# **FIRE SUPPRESSION SERVICES, INC.**

## **EXHAUST DUCT DEFICIENCIES.**

The grease exhaust ducting you asked me to inspect at Heritage Gardens Care Center in Springville Utah was, for the most part, inaccessible for inspection.

## **RANGE GUARD SUPPRESSION SYSTEM DEFICIENCIES.**

### Overall view: Heritage Gardens Springville Kitchen Hood Exhaust

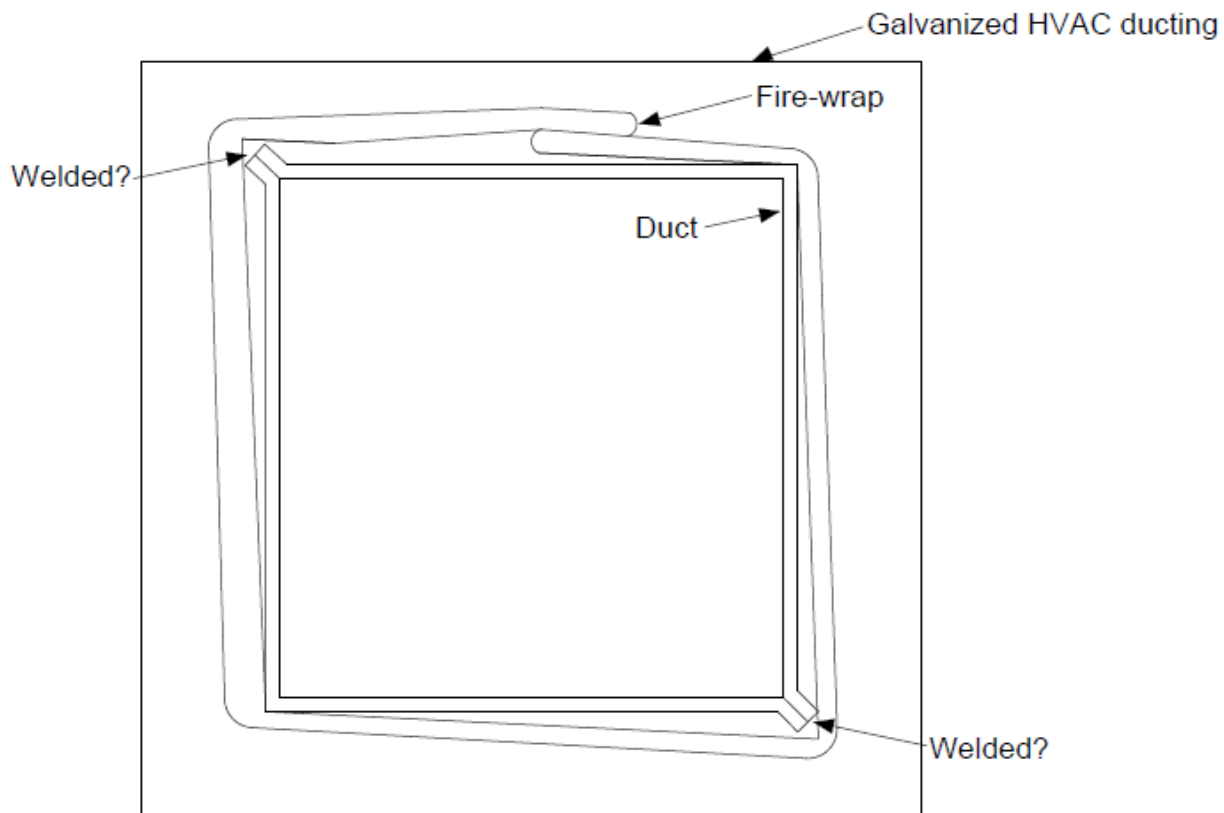
NOTES: (1) Could not verify if duct joints and seams are welded.  
(2) Could not verify if fire-wrap is banded or if seams are taped.

## TOP VIEW OF DUCT

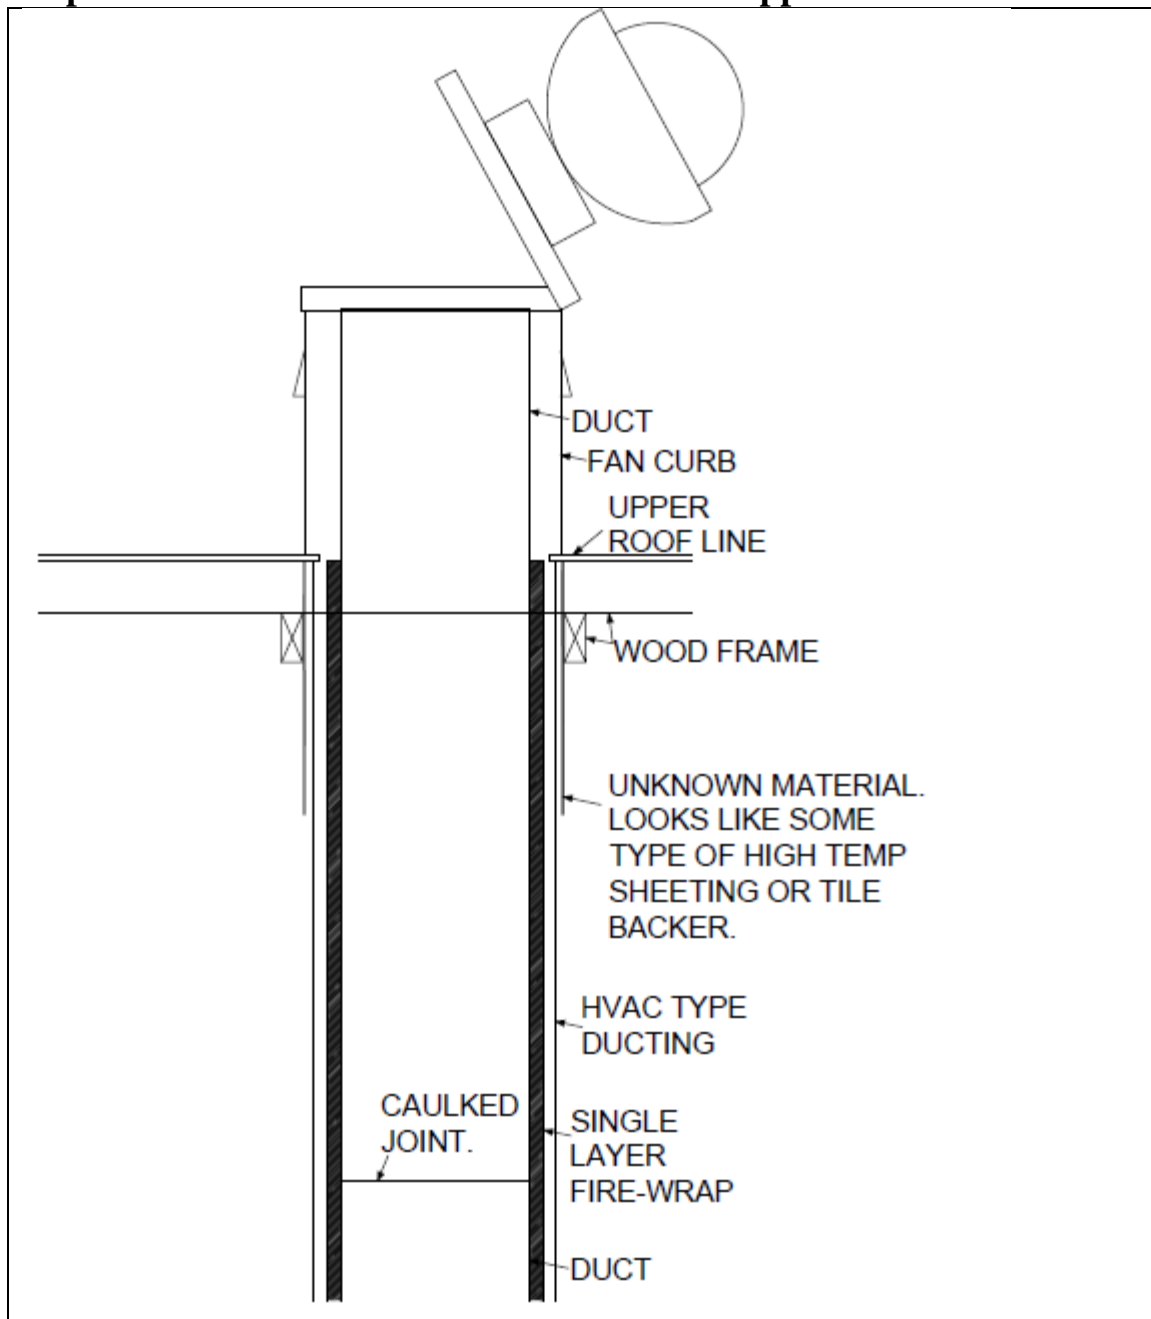
From the upper end of the duct I could see that caulk had been used in the seams and joints however I was unable to determine if they had been welded.

## Expanded view of a Section of Duct: Fan & upper duct

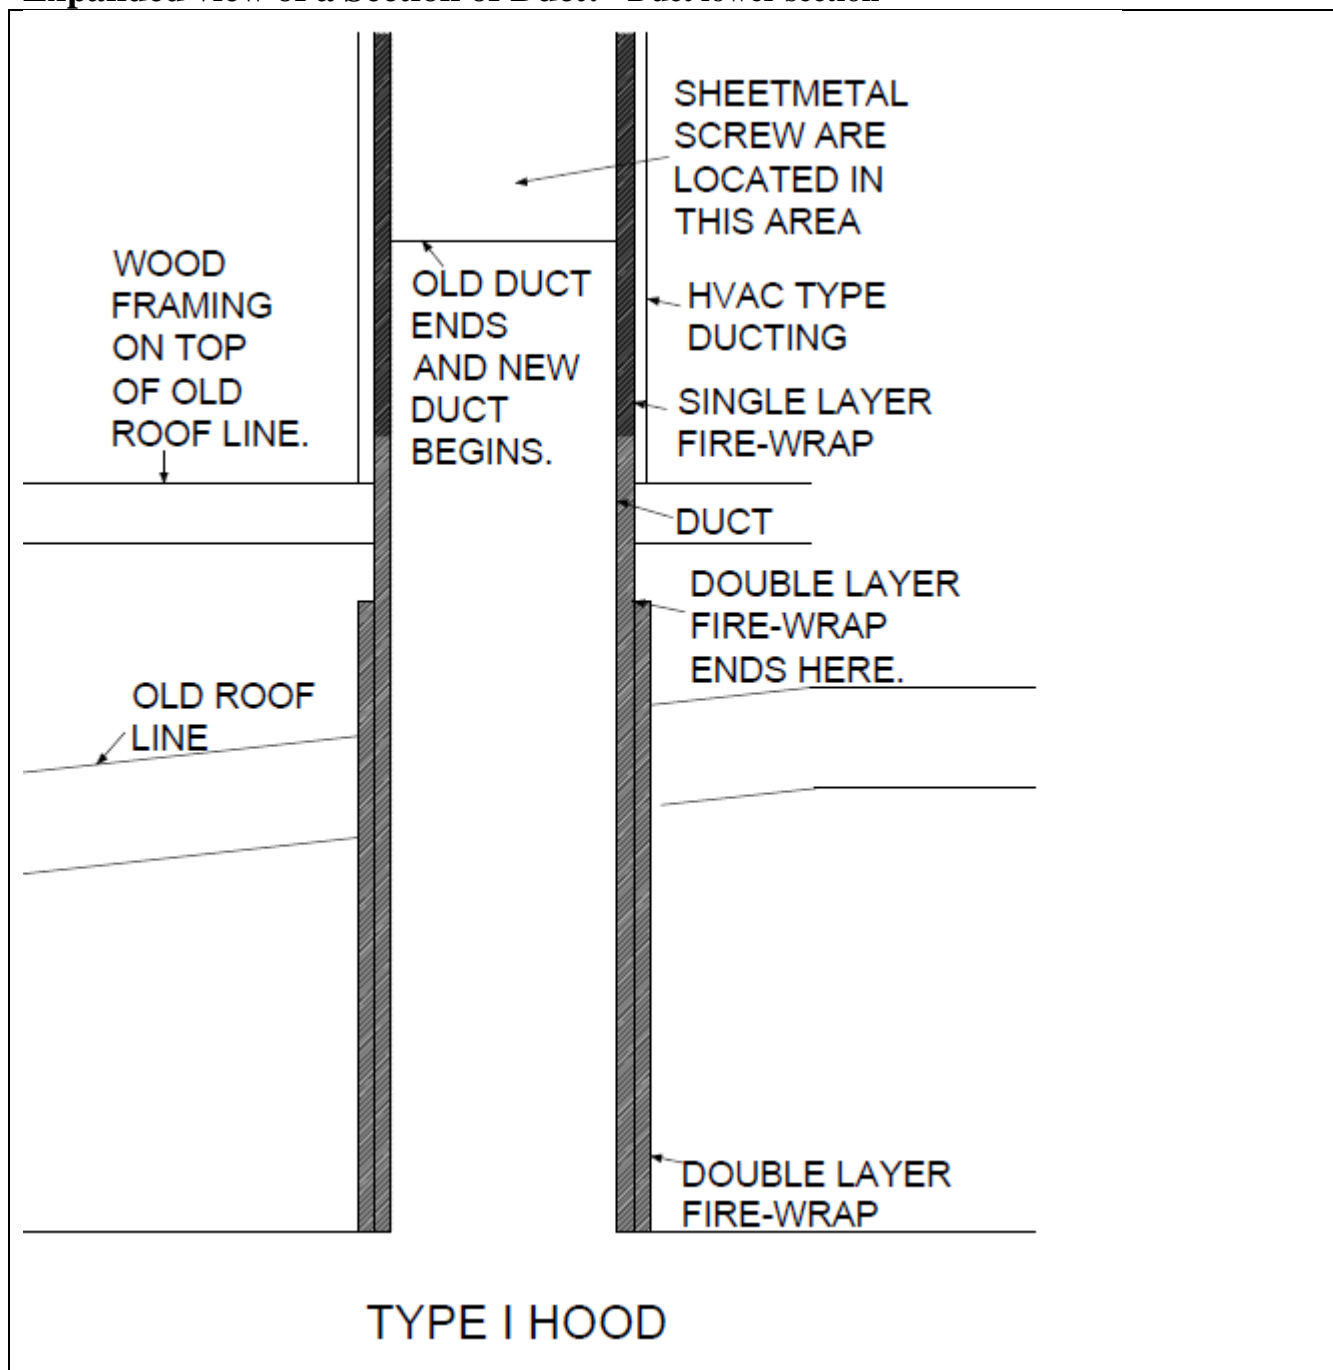
I could see that the older portion had been welded to the hood from inside the plenum; the seams were welded, and had 2 layers of fire-wrap.

I was able to determine the new upper portion had 1 layer of fire-wrap but it did not extend to the upper end of the duct into the fan curb.

## Kitchen Suppression System with KimCo tags as a Dry Chem?

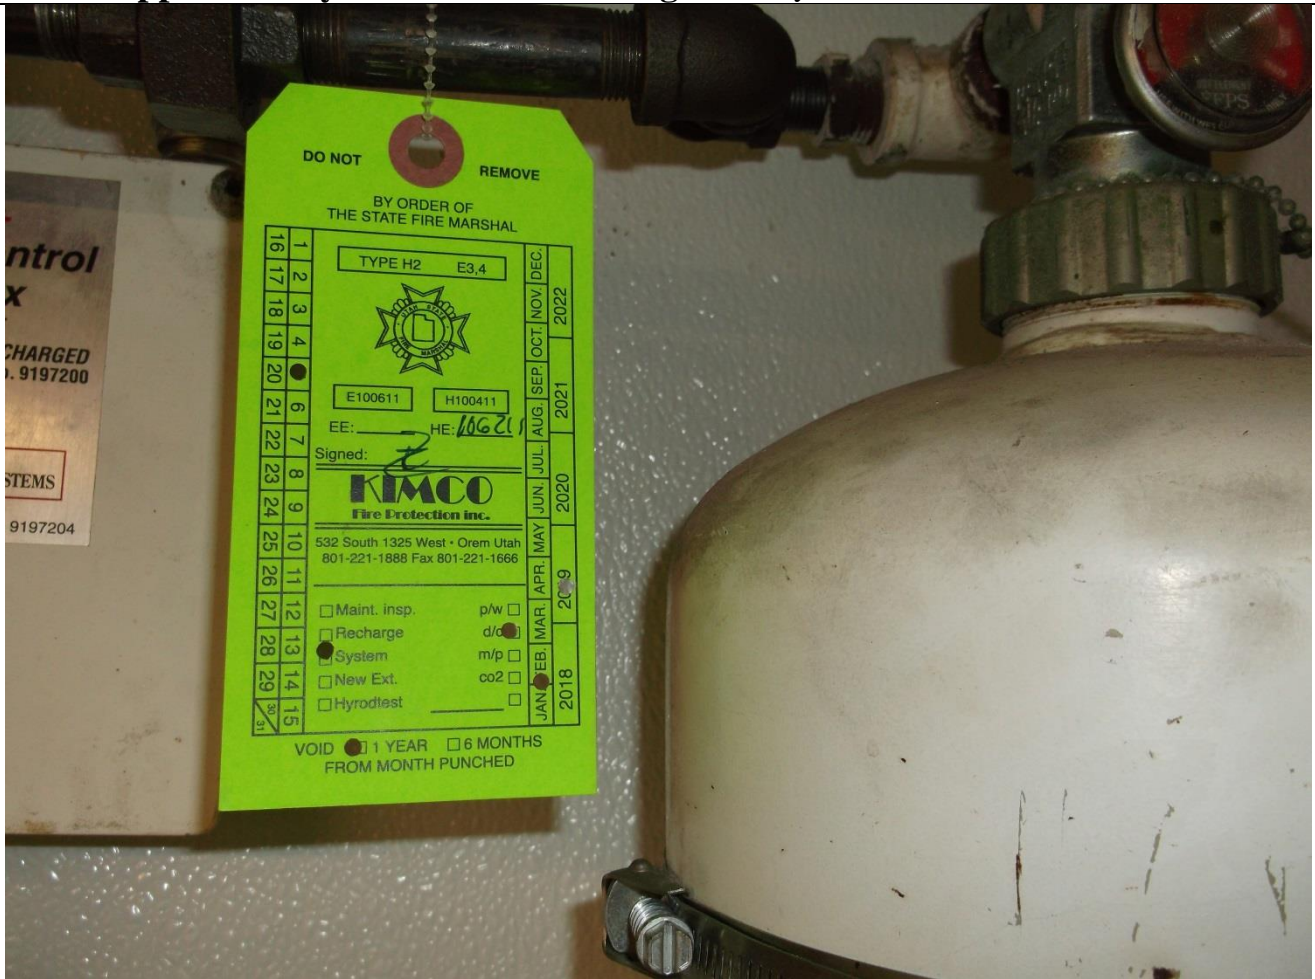
KIMCO Fire Protection Inc. tags are attached to the kitchen hood suppression system (dated February 5, 2019). Note from my photo the tag was punched D/C (*dry chemical*).
